**Source:** Ericsson

**Title:** Answer to questions from Fujitsu on IPDL

This document answers questions raised by Fujitsu on the Idle-Period Down-Link (IPDL) positioning method. The original Fujitsu contribution to the 3GPP RAN WG1 reflector is attached in section 3.

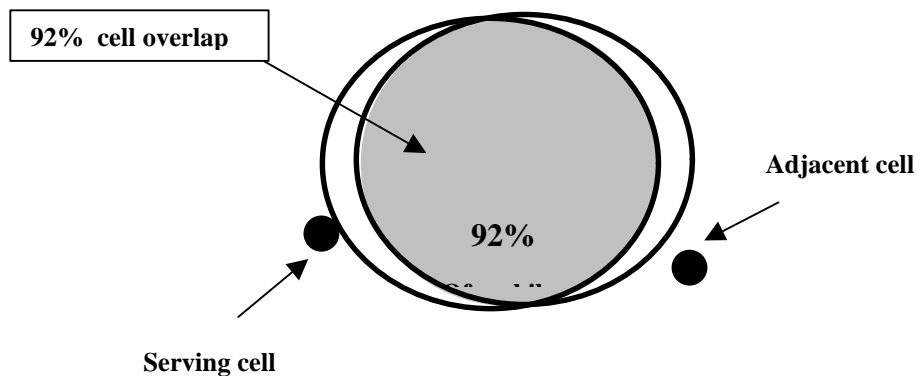
In the conventional cellular networks, where “frequency reuse” can be used for cell orthogonality, adjacent cell transmit power is not an issue. In such cells a “broadcast” or “pilot” channel can be transmitted at maximum allowed power, without any performance degradation in the neighbouring cells (provided the reuse is planned to meet the required CIR). However, in a CDMA network with a “one-cell reuse”, to maximise system capacity, the forward common control channels (PCCPCH and CPICH) have to be transmitted such that they do not interfere excessively with the adjacent neighbouring cells, reducing the network capacity unnecessarily (this is specially critical on the downlink, which has a lower capacity compared to the uplink of the network). Therefore, in CDMA networks, it is desirable to “hear” a single “pilot” channel (the serving cell), until a mobile is near a soft handoff region. This is usually achieved by antenna tilt and antenna height adjustments. Static power control of the BS transmit power can also be used to control cell footprint, however, this has the disadvantage of reducing the indoor penetration and hence coverage. Looking at figure 8, the probabilities of detection of other cells seem very similar to conventional systems with “frequency reuse”. Therefore it is still not clear whether there is excessive “Pilot Pollution” in your simulations or not? If you look at the cell geometry, you will see the implication of **“92% of mobiles can detect 2 sites or more”** cell overlap, and hence see my concern. I have tried to show a 92% cell overlap in the figure below;

So as you can see the cells are virtually on top of each other. In such scenario, detection of far away sites is more probable, facilitating forward positioning with the required accuracy. However, this detection capability is at the expense of system capacity. Reducing the cell overlap will reduce the ability to detect distant sites, leading to;

- Increase repetition of “Idle” slots, reducing system performance further.
- Increased duration of “Idle” slots, reducing system performance further.
- Better UE receiver performance and more UE processing, leading to higher terminal cost and shorter battery life.
- And at worst, inability to meet the required accuracy.

- 1- **What is meant by “detected Sites”?**
- 2- **What transmit power have been used for CPICH (or PCCPCH) in your simulation to define cells of 1.5 and 4.5 km radius?**
- 3- **Assuming a maximum power of 30 dBm for a DTCH, what is the relative transmit power of CPICH (or PCCPCH) in your simulations?**

In the case of sectored sites, a detected site means that one or more sectors have been detected. This can include more than one sector for one base station. Note that the IPDL detection is not the same as detecting the CPICH for channel estimation, or being able to decode the Primary CCPCH. By "detected" cell we mean that the positioning algorithm has detected at least one peak in the channel impulse response of that cell, and can use that to calculate the time of arrival. After correlating and summing, threshold detection is used to determine whether a candidate peak is “detected”. Please also note that the system simulations are the same as the ones used for the ITU simulations.

33 dBm. Note however that the simulations that we are discussing used the old channel set (based on PCCPCH pilot symbols).

The relative power is 4%.
